# TOWN OF FAIRFAX STAFF REPORT

**TO:** Fairfax Planning Commission  
**DATE:** January 20, 2022  
**FROM:** Linda Neal, Principal Planner  
**LOCATION:** 79 Wood Lane; APN # 002-062-03  
**ZONING:** Residential Single-family RS 6  
**PROJECT:** New residence, accessory dwelling unit, garage  
**ACTION:** Hill Area Residential Development, Excavation and Design Review Permits and Minimum and Combined Side-yard Setback and Retaining Wall Height Variances; Application # 21-17  
**APPLICANT:** Laura Kehrlein, applicant/architect  
**OWNER:** Coby/Jacob Friedman  
**CEQA STATUS:** Categorically exempt, § 15303(a) and (e).

### 79 WOOD LANE

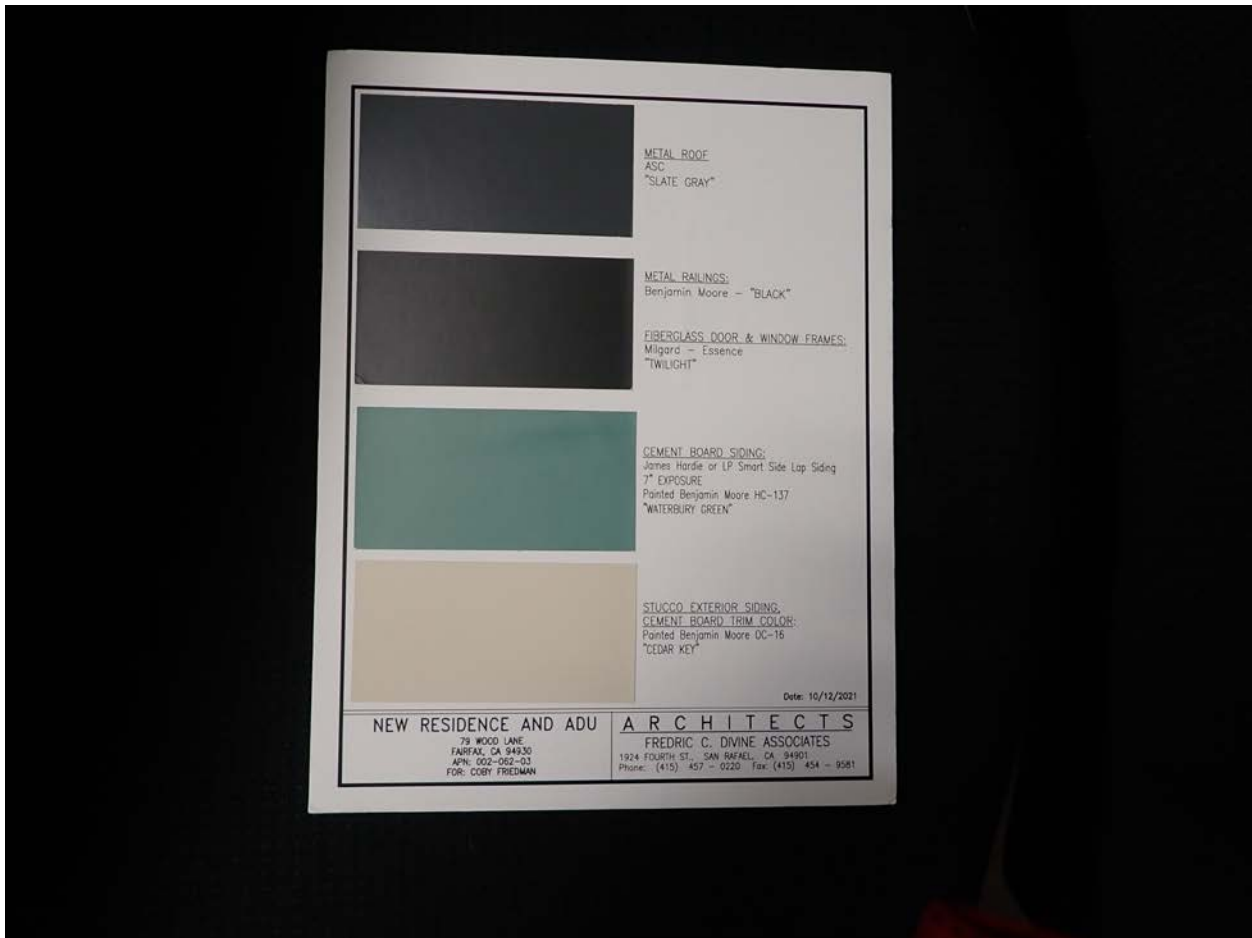
See the previous design compared to the currently proposed design and the revised color palette below.

A survey of plans of other Wood Lane two-story structures has revealed that most of them do not exceed 23 to 24 feet in height, with only one of the structures with plans found in the Town plan retention files reaching 27 feet in height at its roof peak (see table below). The redesigned project with a maximum height above finished grade of 21 feet and roughly 23 ft above the existing grade is now similar to the height of other two-

**SHADE STUDIES**

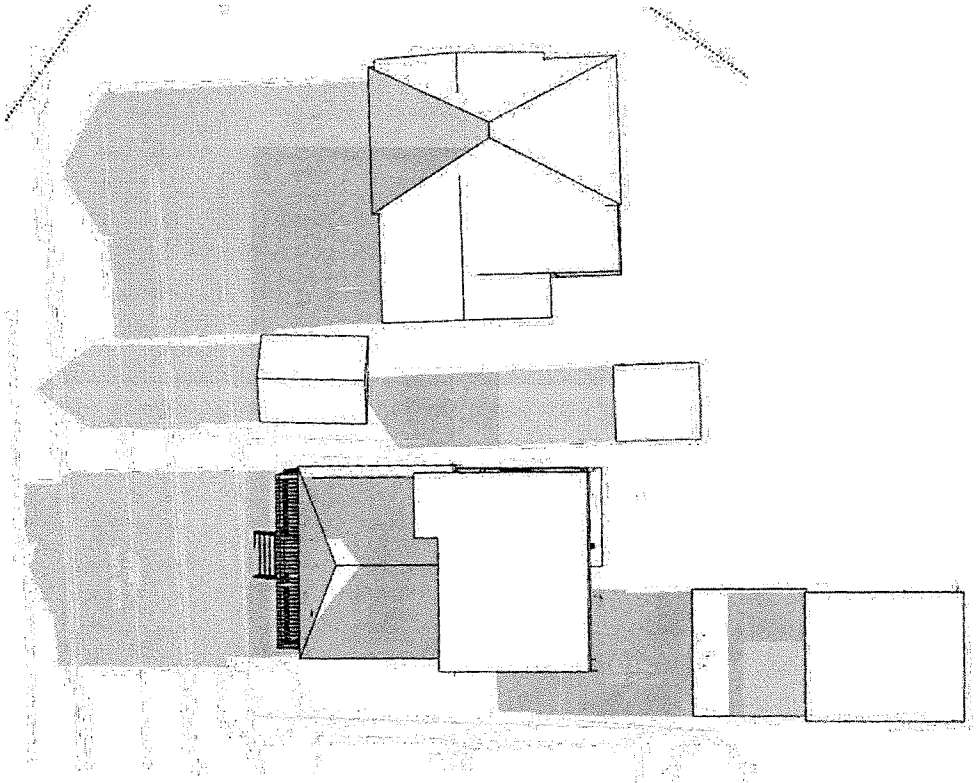
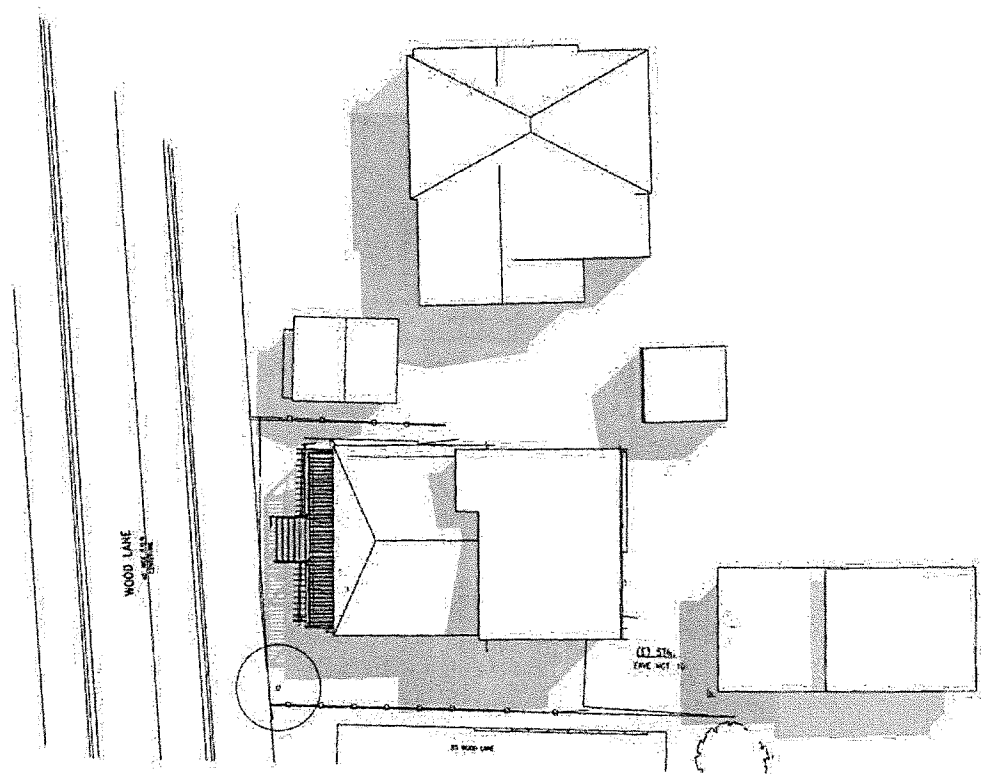
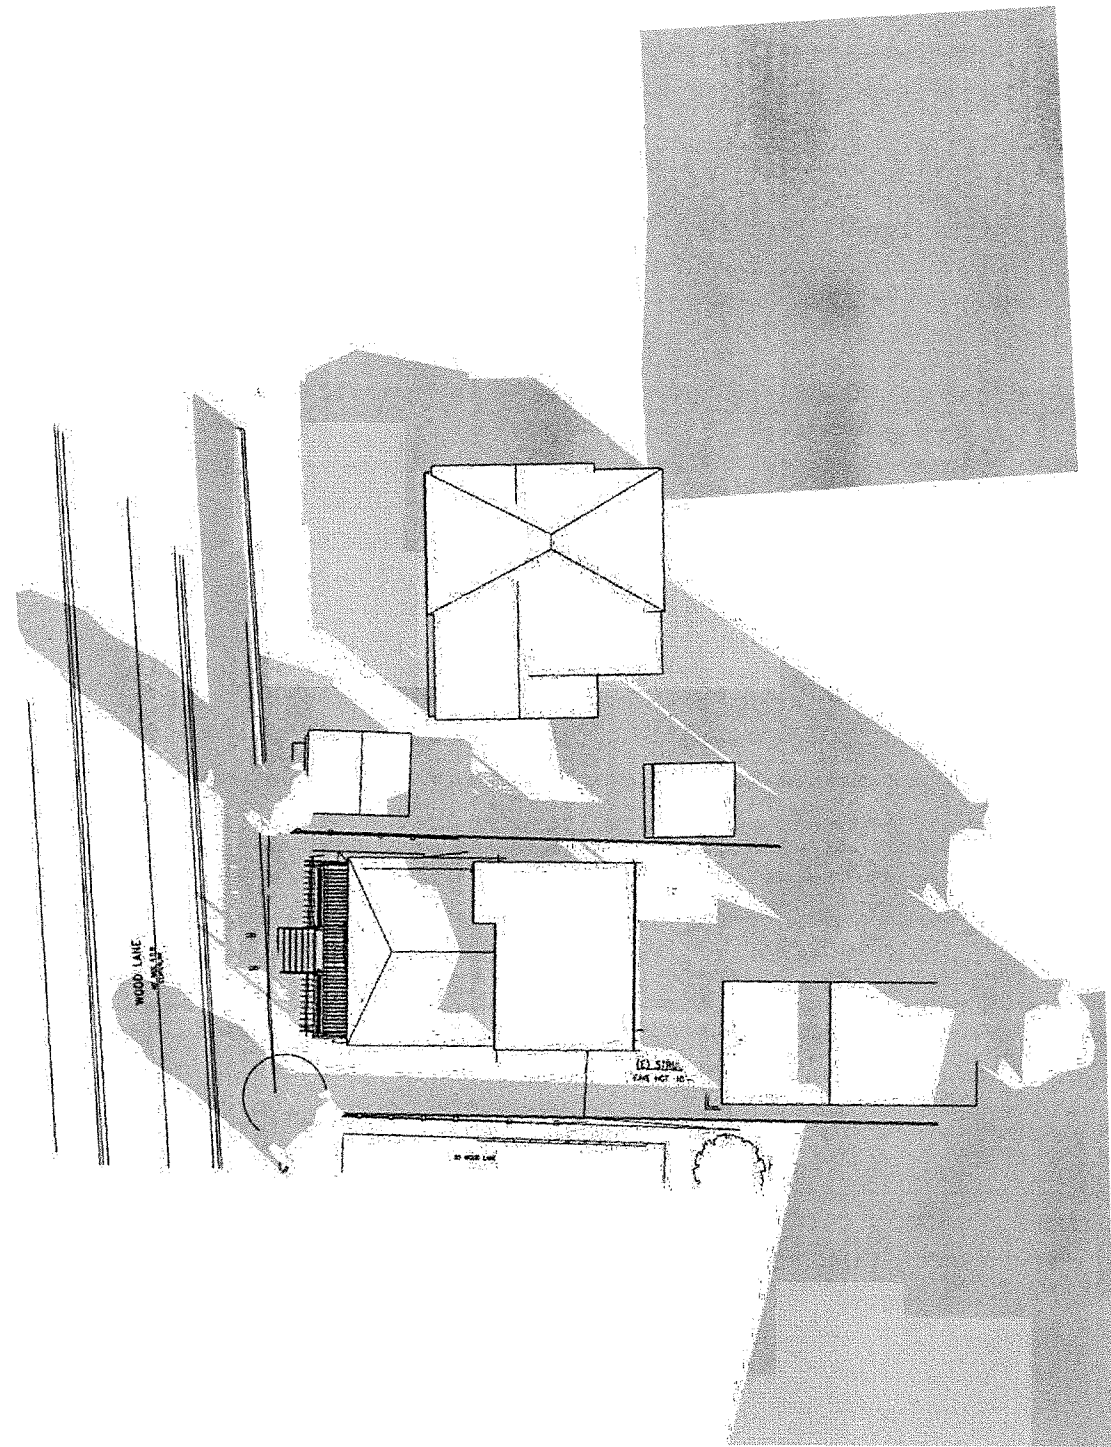
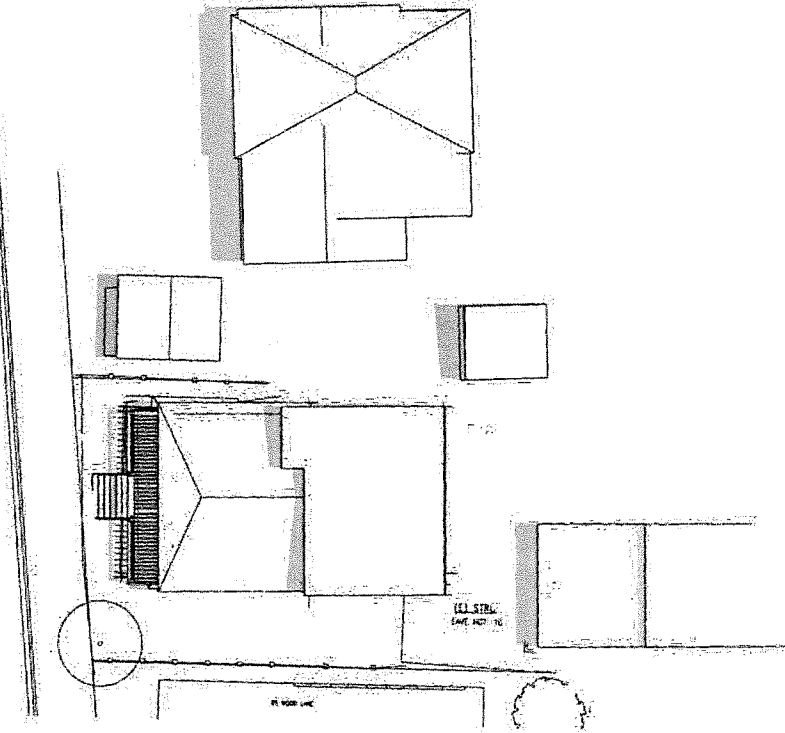
9. Provide revised shade studies for the revised project taking into consideration the shade thrown on the neighboring sites during winter and summer by the densely vegetated rear hillsides so the Commission can get a better idea of the shade thrown by the revised design. The design should minimize shading of the neighbor's solar panels.

The property to the west of the site at 75 Wood Lane recently built an ADU at the front, southwest corner of the property that included rooftop solar panels. A review of the revised shade studies for the new design provided by the applicant's consultant reveals that the revised design will not cast shadows on the ADU solar panels during either the winter or the summer.

**2** PROPOSED BASEMENT FLOOR PLAN  
SCALE: 1/4" = 1'-0"

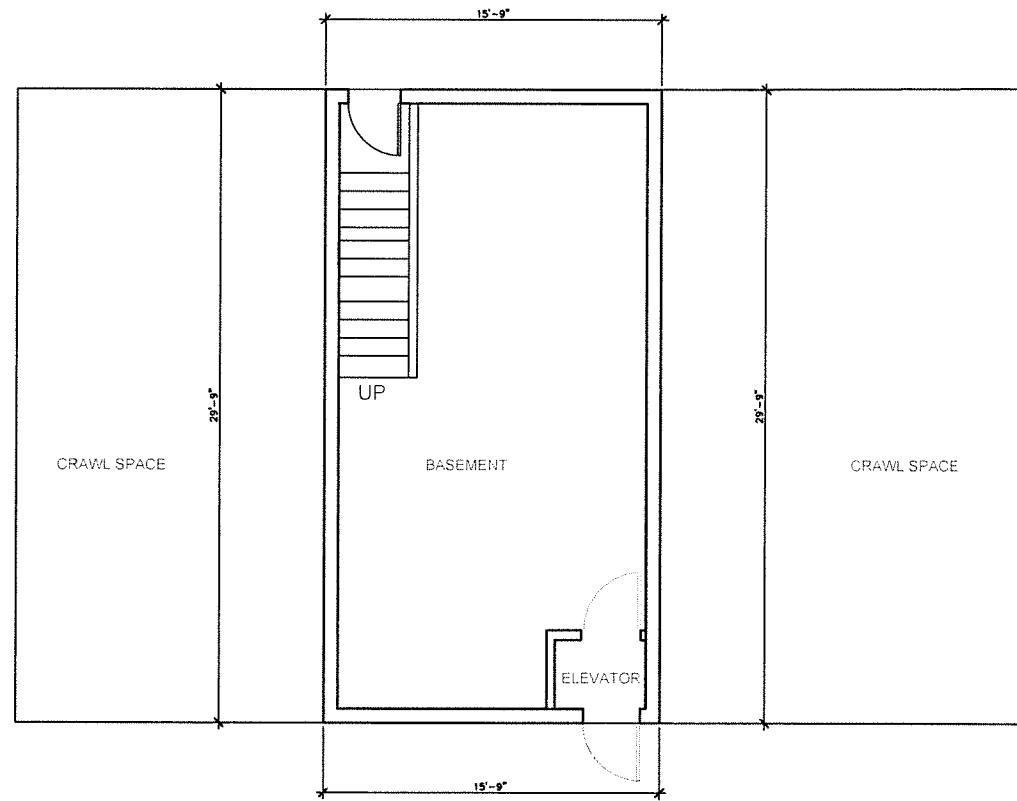
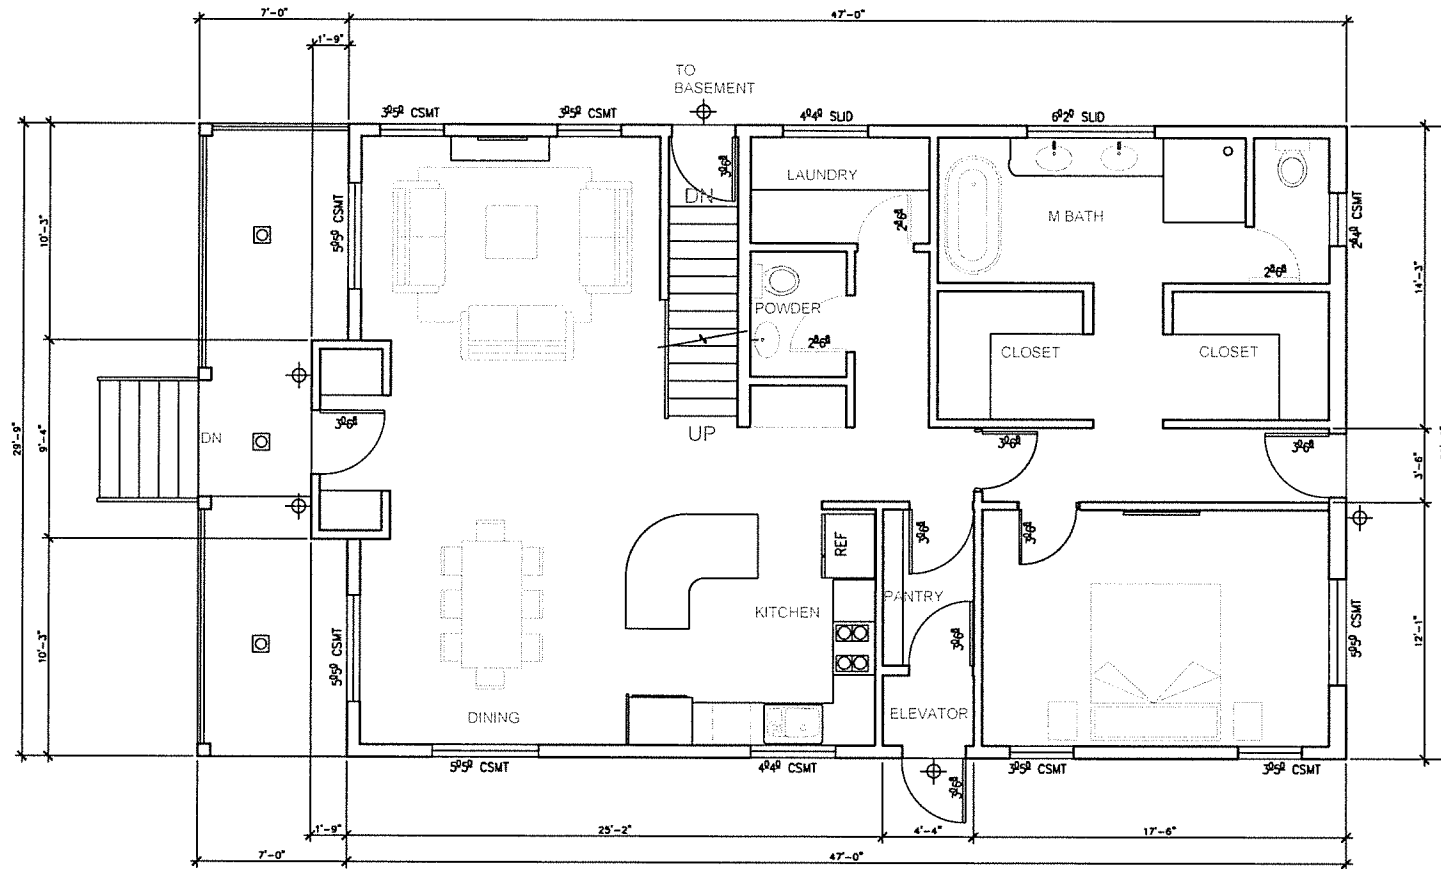
While the height of the current design has been significantly decreased, staff is still unable to make the following required finding to recommend approval of the project as proposed. The current design includes an even larger basement than the previous design and the applicant will have a substantial use of the property, a three bedroom, three ½ bathroom, residence, garage and ADU, without construction of a basement. Removal of the basement from the project plans will decrease the amount of project excavation by 65 cubic yards.

1. The basement shall be removed from the plans prior to submitting them for building permit approval.
2. The windows on the upper floor, east and west sides of the house be modified with either windows having a minimum lower sill height of 6 feet above the finished floor elevation or be non-operable and with obscured glass.

2 PROPOSED EXTERIOR LIGHTING UPPER LEVEL NORTH  
SCALE: 1/4" = 1'-0"

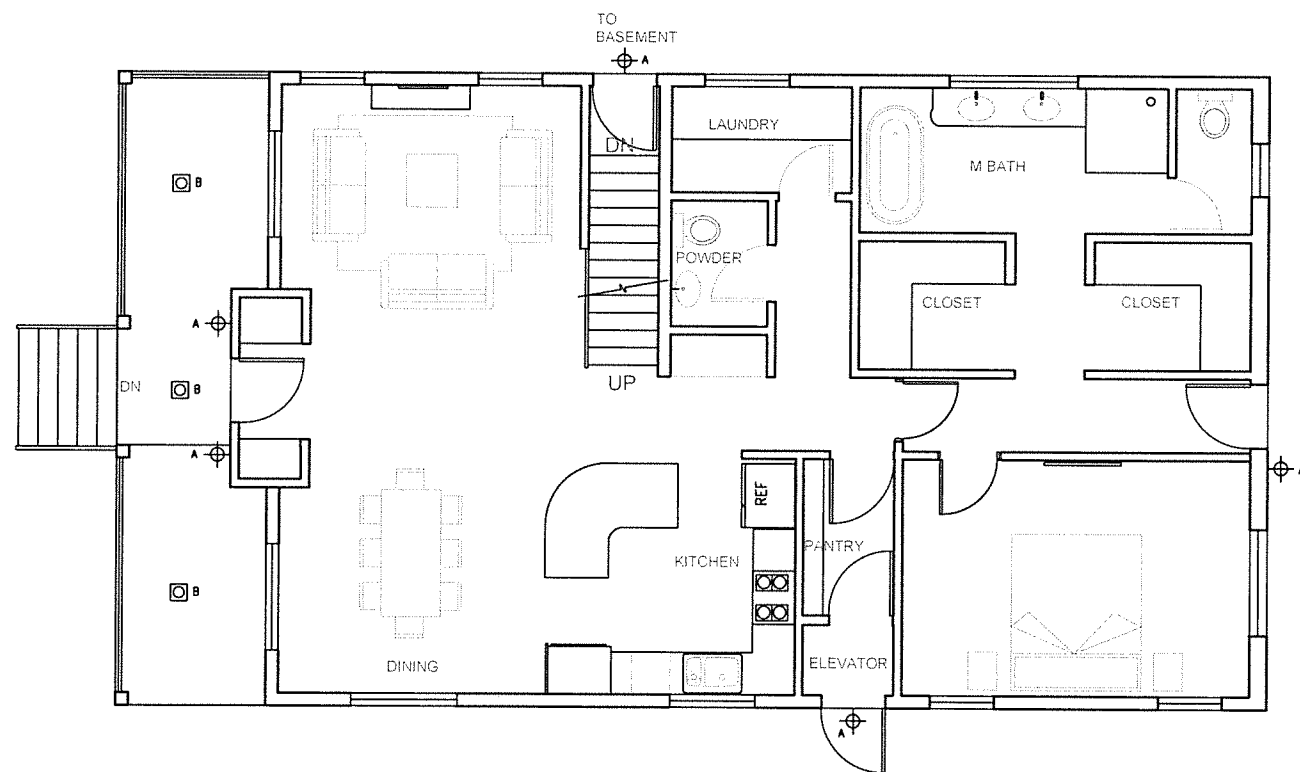
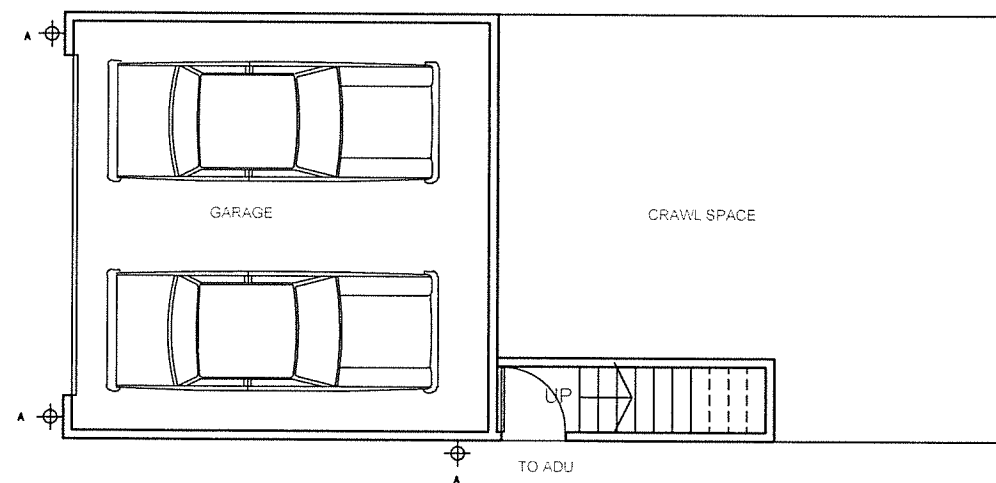
Black, 3000 K, 13-Watt, 1,150 lumen, light fixtures. Although not called out on the lighting plan, five, Elco 6-inch, 3000K, 830 lumen, soffit lights will be installed, three to light the interior of the covered porch area and two to light the rear covered deck. The lighting plan can be found on page A2.3 of the revised project plans.

51. All the exterior fixtures must be dark sky compliant (fully shielded and emit no light above the horizontal plane with no sag or drop lenses, side light panels or uplight panels) as well as compliance with color temperature to minimize blue rich lighting. The lighting plan shall be submitted with the building permit application and be approved by the Planning Department prior to issuance of the project building permit. The lighting shall not emit direct offsite illumination and shall be the minimum necessary for safety.
